CP-201000251
Log # TXNB-10013

SUBJECT: COMANCHE PEAK NUCLEAR POWER PLANT, UNITS 3 AND 4
DOCKET NUMBERS 52-034 AND 52-035
RESPONSE TO REQUEST FOR ADDITIONAL INFORMATION REGARDING THE
ENVIRONMENTAL REVIEW AND SUPPLEMENTAL INFORMATION FOR
PREVIOUS ENVIRONMENTAL QUESTIONS

REFERENCE: Letter, M. Willingham to D. Woodlan, "Request for Additional Information Regarding the Environmental Review of the Combined License Application for Comanche Peak Nuclear Power Plant, Units 3 and 4," dated January 15, 2010 (ML093280707)

Figure 1
 Pipeline Stream Crossings
 CPNPP Site to Lake Granbury

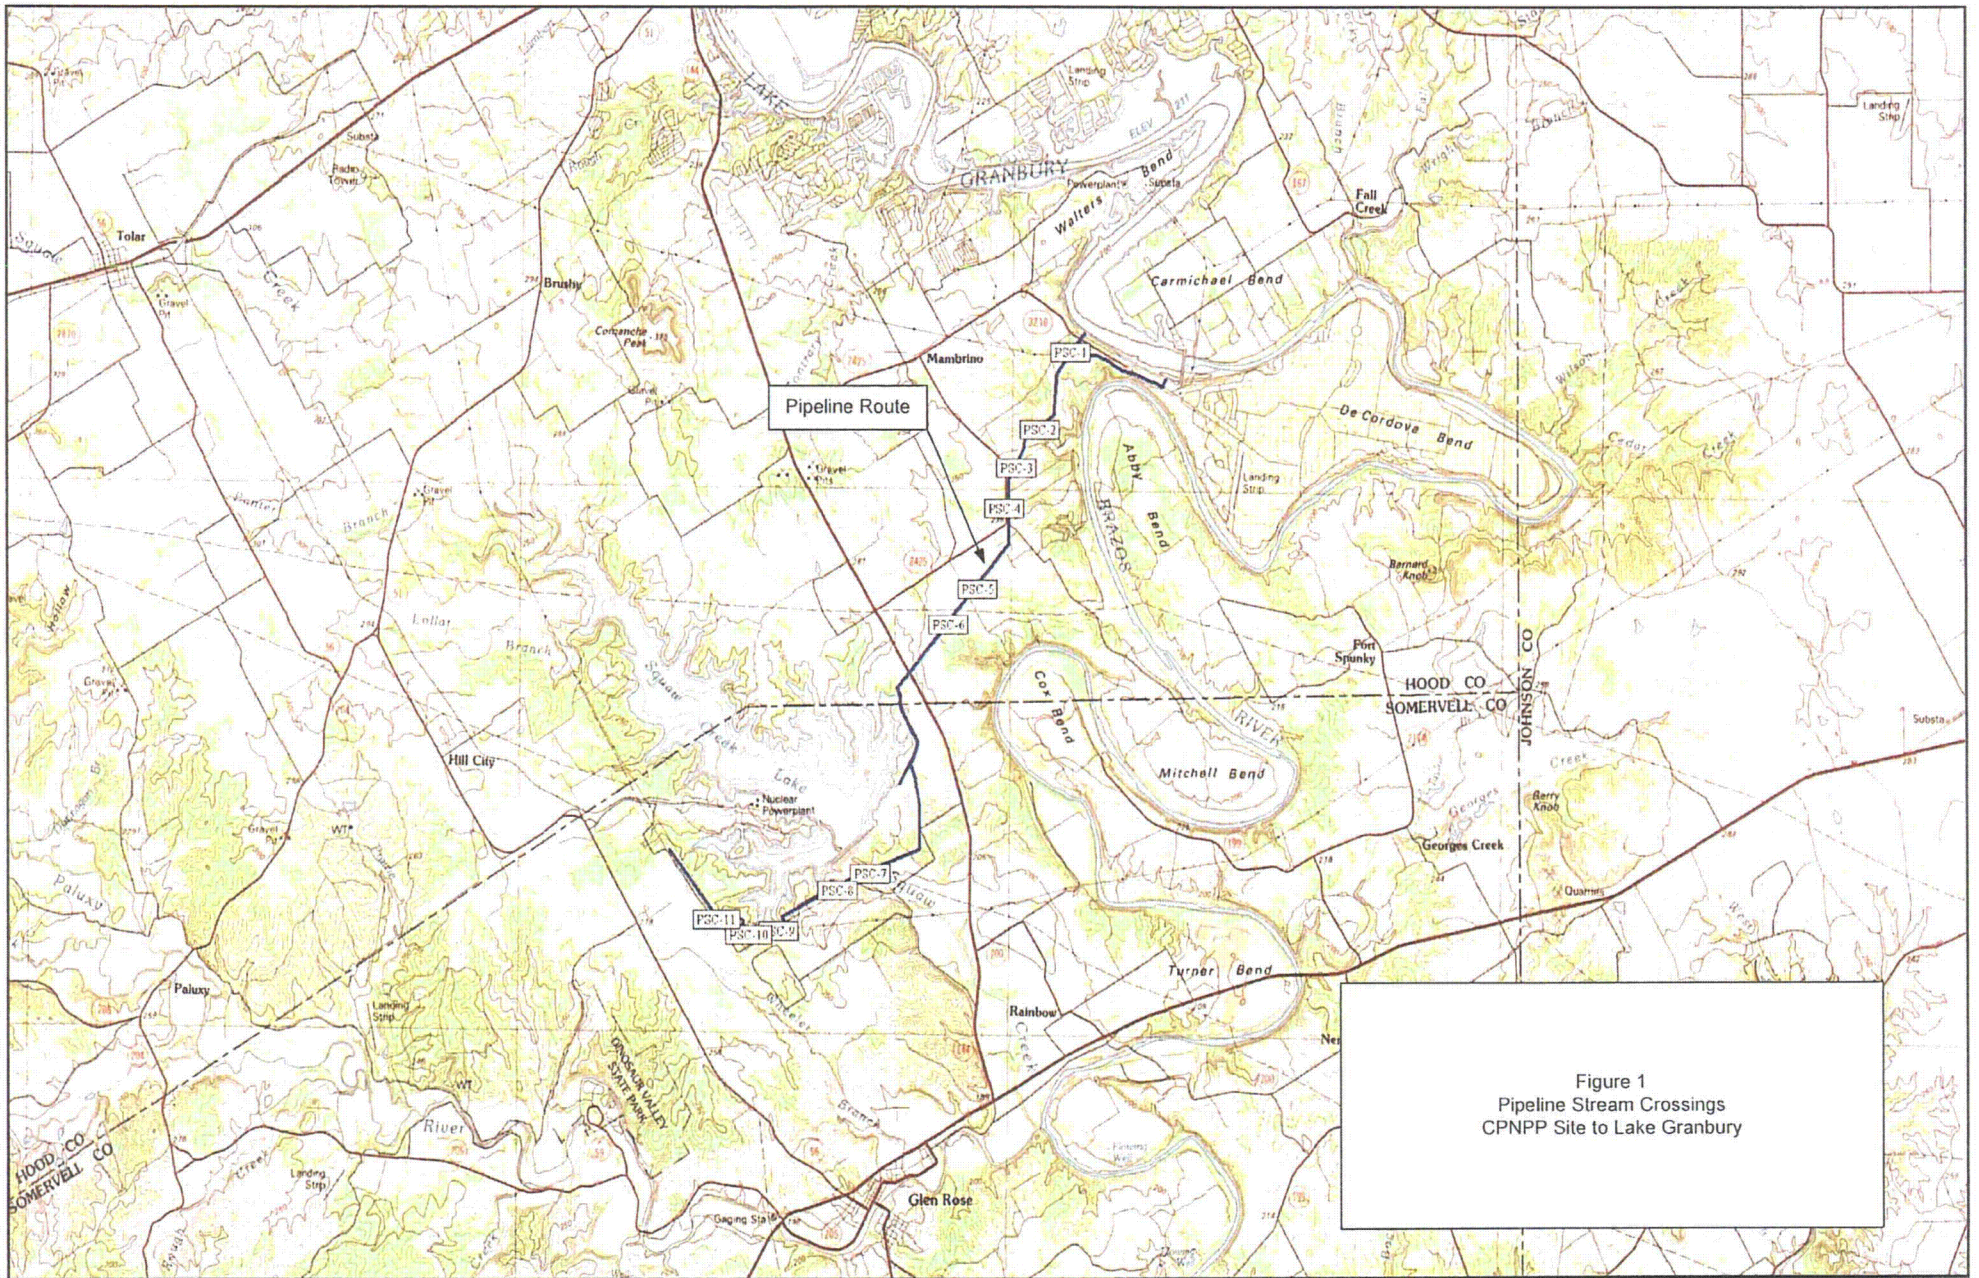
Provide descriptions of any streams that would be crossed by the proposed pipelines between Lake Granbury and CPNPP Units 3 and 4, including their ecological and hydrological characteristics. Provide an estimate of the number of linear feet of streams that would be affected by the construction of Units 3 and 4 pipelines, as well as transmission lines. These data should be provided for each right-of-way (ROW).

Additional cooling water intake and discharge pipelines are expected to be constructed for CPNPP Units 3 and 4 extending from the plant to Lake Granbury (ER Figure 1.1-4). The pipelines are expected to occupy an existing 50-ft ROW and are expected to run parallel to the existing water pipelines. Intake and discharge structures for CPNPP Units 3 and 4 are expected to be placed to the north of and adjacent to the existing Units 1 and 2 intake and discharge structures on Lake Granbury. As discussed in Subsection 2.4.1.2.2, no wetlands or habitat for threatened or endangered species are located on the pipeline ROW. Vegetation consists mainly of grassland and Ashe juniper. Land-use impacts to the ROW during construction are discussed in Subsection 4.1.2. Luminant intends to tunnel at all pipeline stream crossings to minimize or eliminate potential disturbance to streambeds and riparian areas during pipeline construction. Additionally, existing vehicular infrastructure in place at stream crossings from the construction of the existing pipeline is expected to be utilized for CPNPP Units 3 and 4 pipeline construction and maintenance. Streams encountered along the pipeline route and estimated ROW acreages at stream crossings are summarized in Table 1 and stream locations are shown on Figure 1.

Figure 3.3-1 Water Balance (Sheet 1 of 3)

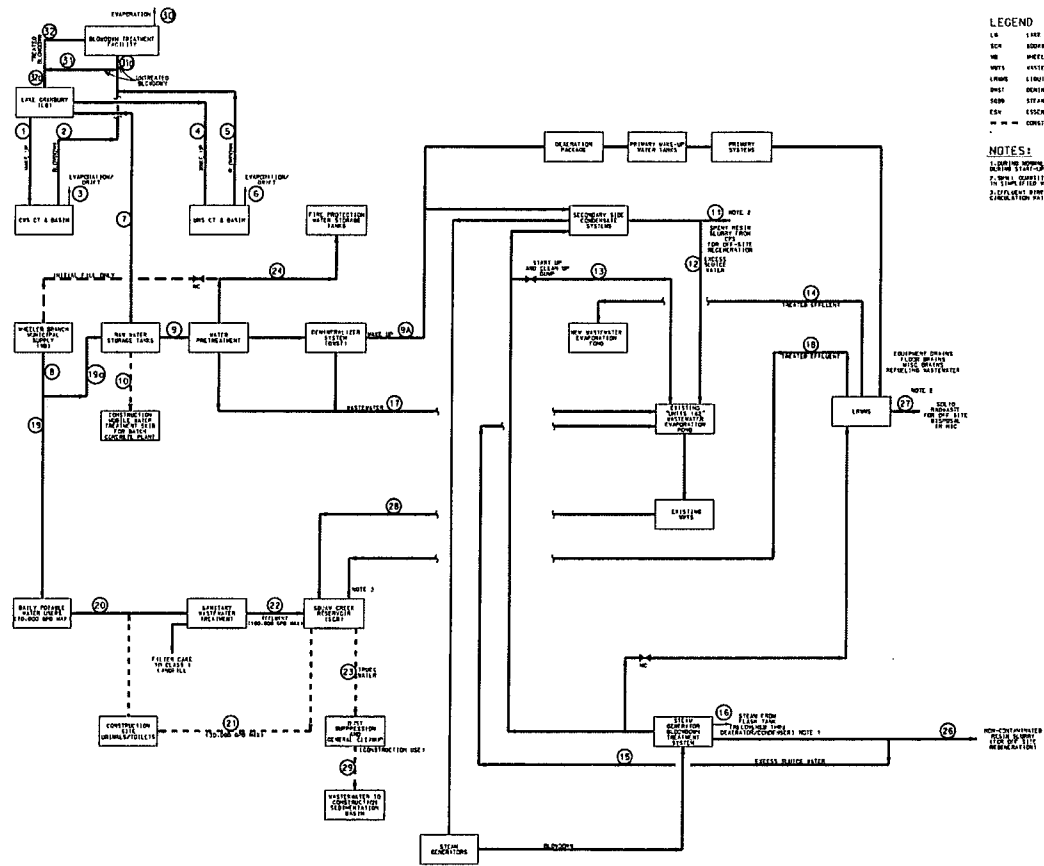
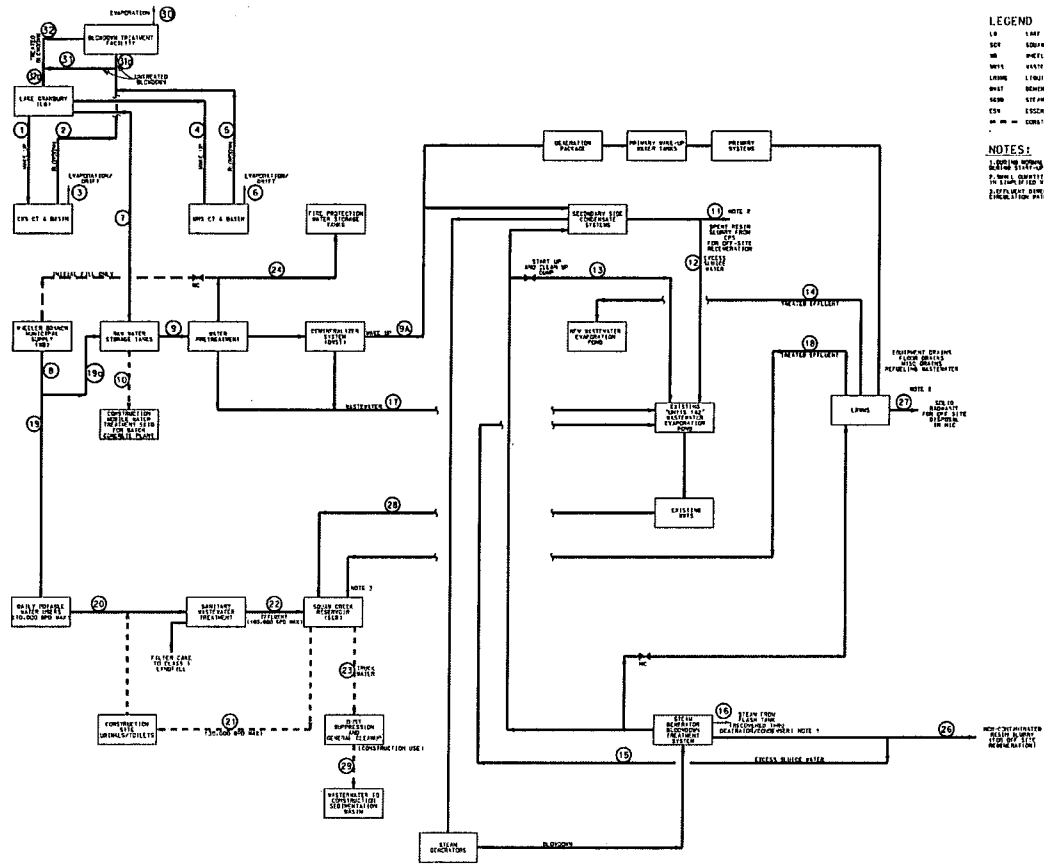
Provide an updated version Figure 3.3-1 Water Balance for normal full-power operations. The figure should show all elements of the system, including components missing from the current version such as the cooling tower basin and BDTF. Accurately represent the relationship between components so that it is clear which components are shared, such as the cooling tower basin, and which serve only an individual unit. Include inputs and discharges to the water system for Units 1 & 2. For minor and intermittent water uses and discharges, provide sufficient information about rates and timing to allow the staff to estimate annual flows.

Provide clarification on water requirements for facility operation, as listed in Table 3.3-1, Figure 3.3-1 and the text of the ER. Clarify apparent inconsistencies and revise Table 3.3-1 as appropriate.

If any value given for "normal flow" in Table 3.3-1 or section 3.4-1 does not represent a continuous withdrawal, indicate the expected frequency and duration of the withdrawal requirement. Also, (1) clarify whether construction water would be used during operation and (2) supply the missing information in row 9 of the table on sheet 2 of Figure 3.3-1.

Figure 3.3-1 has been updated to include the BDTF. The cooling tower designations have been changed to be consistent with revised Figure 3.4-1. The supporting table (pages 2 & 3) has been revised to indicate single unit and two-unit flows; duration and flow; users/discharges associated with Unit 3 and 4 construction activities.

Figure 3.3-1 has been extensively revised to display additional elements on Sheet 1. The corresponding item numbers on Sheets 2 and 3 have been revised to more clearly indicate whether the values are per unit, for two units or for the whole site (four units). In addition, a note has been added to Sheets 2 and 3 to indicate all flows are continuous. The notes on the column on the far right side of Sheets 2 and 3 have been extensively revised. Since some of the values from Figure 3.3-1 are used on Table 3.3-1 and elsewhere in the text, additional revisions have been made.

Figure 3.4-1 Simplified Water Use Diagram

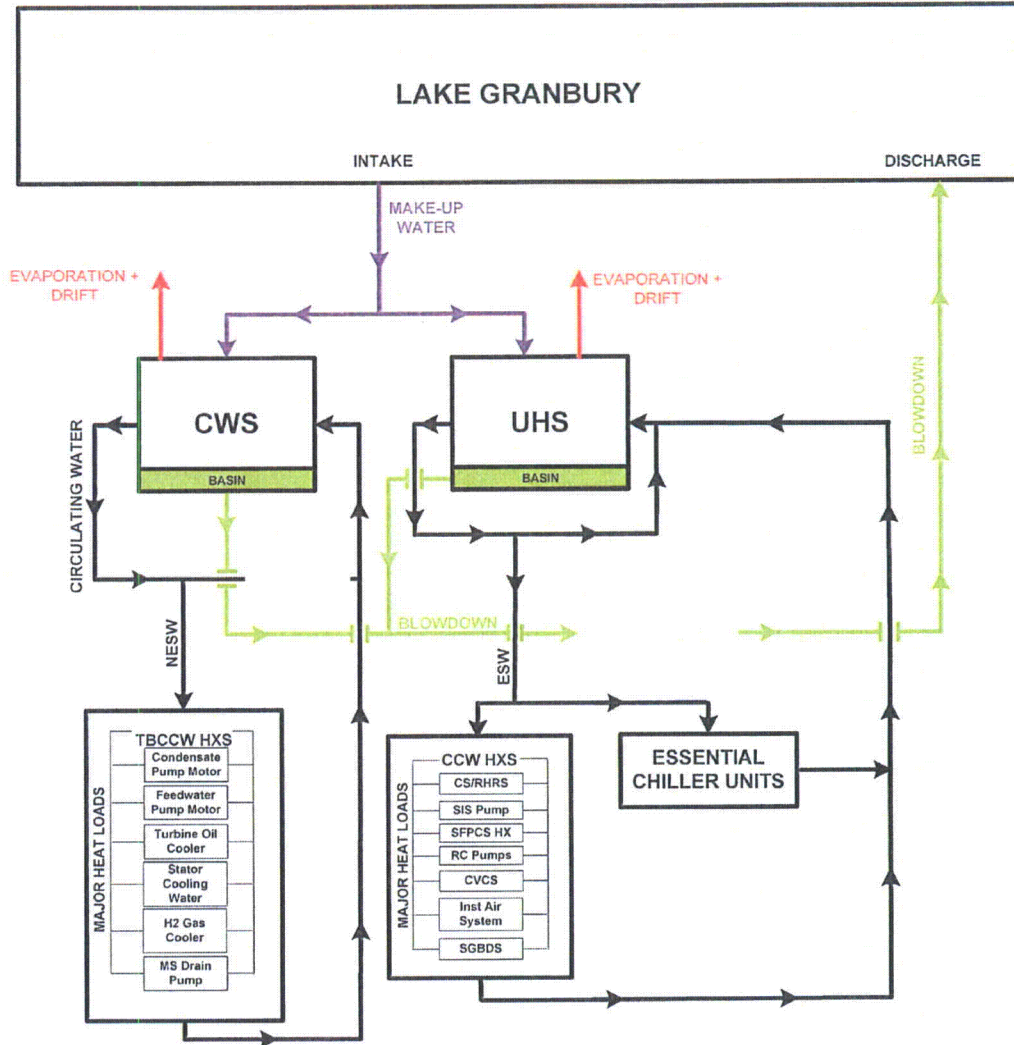
Provide an updated version of ER figure 3.4-1 which shows a schematic representation of the proposed Comanche Peak Nuclear Power Plant (CPNPP) cooling system water use during normal operation. Specifically, the figure should include:

- All cooling loads;
- The cooling tower basin;
- The Blowdown Treatment Facility (BDTF) and all other cooling water treatment systems;
- Any and all water uses, in addition to cooling water, that add water to or withdraw water from the cooling water system.

It is unclear whether the ultimate heat sink (UHS) and circulating water system (CWS) share the same cooling towers and basins. Clarify the flow of water from the CWS and UHS to the cooling tower(s) and basin(s). If the UHS cooling towers are separate from the CWS cooling towers, revise figure 3.1-1, as well, to show the location of the UHS cooling towers.

Figure 1.1-5 Electrical Transmission Corridors

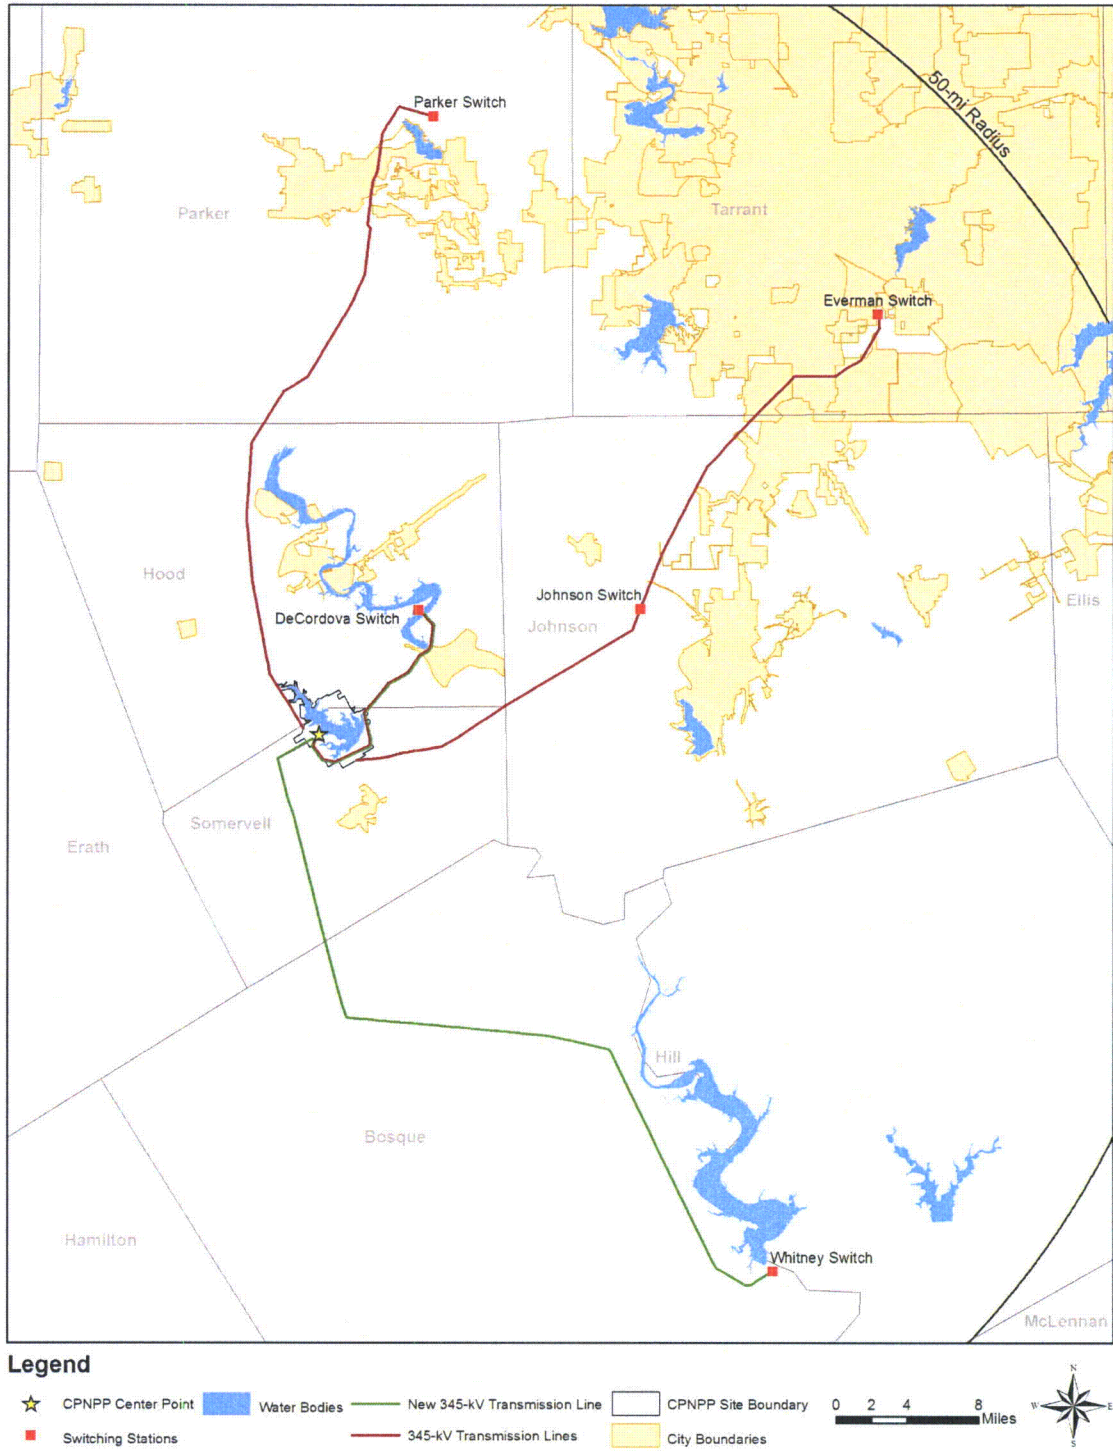
- Describe the route/alignment and cumulative width of the existing 185-kV and 345-kV DeCordova rights-of way (ROWs).
- Figure 1.1-5 and 3.7-4 indicate that the proposed ROW would either be adjacent to the existing ROWs or it would be built along a completely new ROW. Describe the cumulative width (i.e., the combined width of the three ROWs) and route/alignment if the new transmission line were built adjacent to the current ROWs.
- Provide an explanation and environmental implications for the differences between the MVA rating of the DeCordova circuit and other transmission line circuit MVA rating.

The existing DeCordova transmission lines have a 230-ft ROW and their alignment is illustrated on ER Figures 3.7-4 and 1.1-5. The proposed line is anticipated to run adjacent to the existing lines, adding an additional ROW of 160 ft. This creates a cumulative ROW of 390 ft. The ER text, tables and figures have been revised.

Figure 9.2.4-1R Potable and Sanitary Water System Flow Diagram (Sheet 1 of 2)

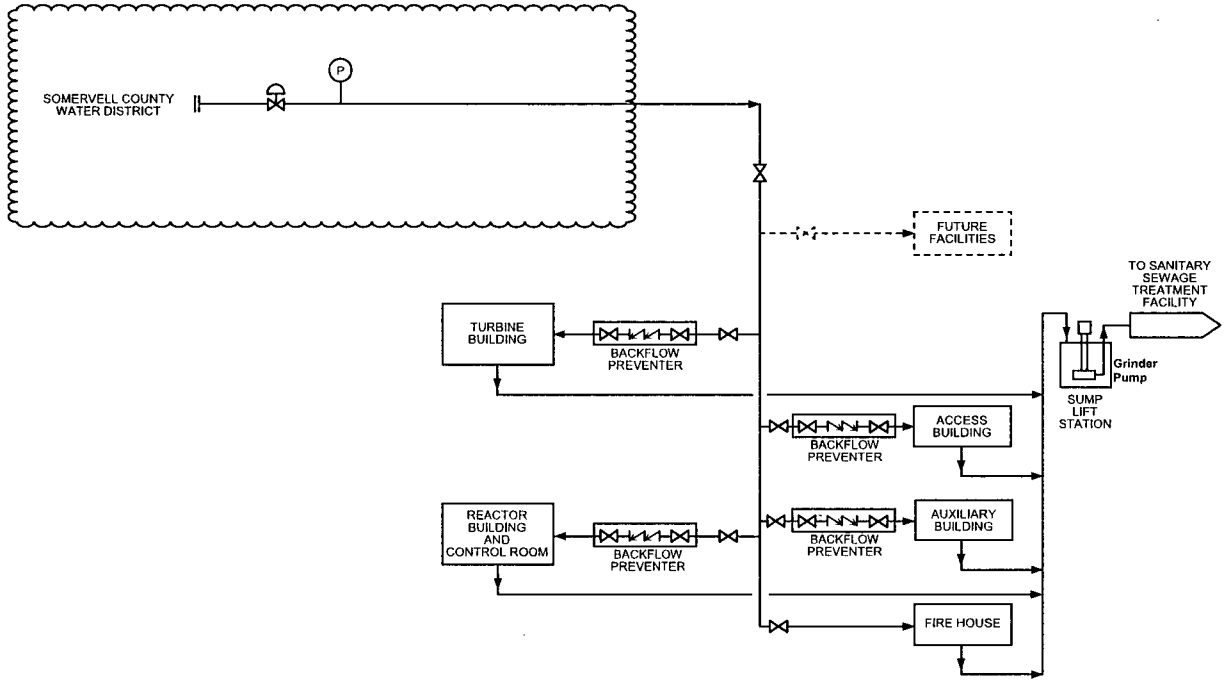
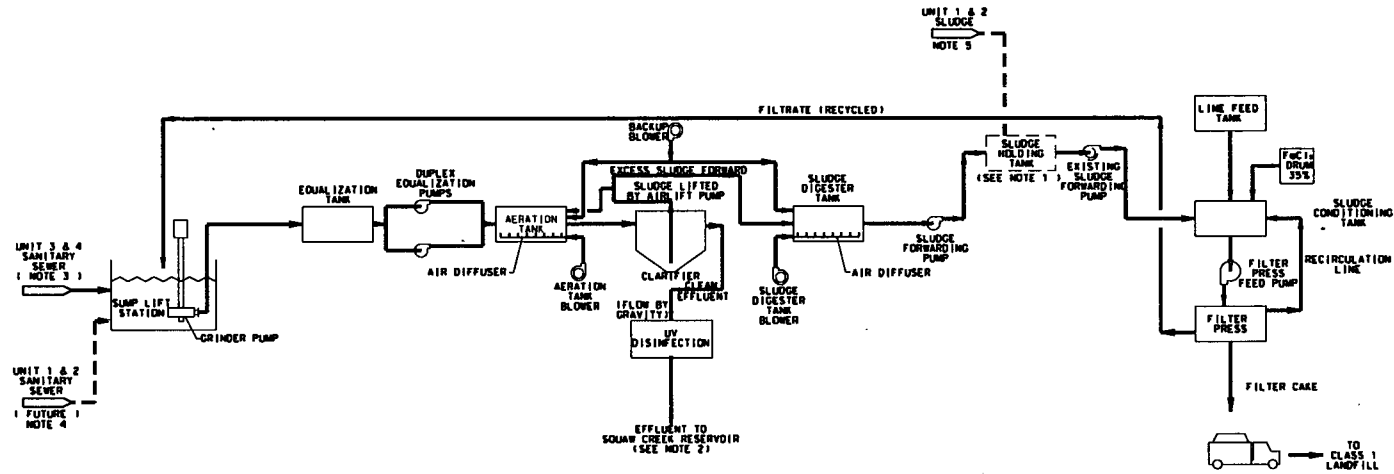
Provide a detailed explanation of the proposed sanitary wastewater system with a diagram illustrating the connections between the components, and explain the connections with the system for Units 1 and 2 and how it will be utilized.

Explain in detail the relationship between the Unit 1 and 2 sanitary wastewater system and the Unit 3 and 4 sanitary wastewater system. For instance, does the Unit 3 and 4 system utilize the Unit 1 and 2 system filter press, or is it only for "excess sludge"?

A process flow diagram of the sanitary wastewater treatment system with additional detail and clarification has been added to the FSAR as Figure 9.2.4-2R, which supplements FSAR as Figure 9.2.4-1R.

A new sanitary waste treatment plant will be installed as part of the Unit 3 and 4 construction project. The new system will include a filter press for sludge dewatering. Unit 1 and 2 sludge is presently dewatered using a bag filter system. The Unit 1 and 2 bag filter system will be decommissioned and replaced by the new Unit 3 and 4 filter press, which will have sufficient capacity to dewater sanitary waste sludge from all four units. During Unit 3 and 4 construction, the existing Unit 1 and 2 system will operate in parallel with the new treatment system since neither system alone will have sufficient capacity to treat the waste generated during construction. After completion of Unit 3 and 4 construction, the Unit 1 and 2 sanitary waste treatment system will be decommissioned and the combined sanitary waste from Units 1 – 4 will be treated by the new system.
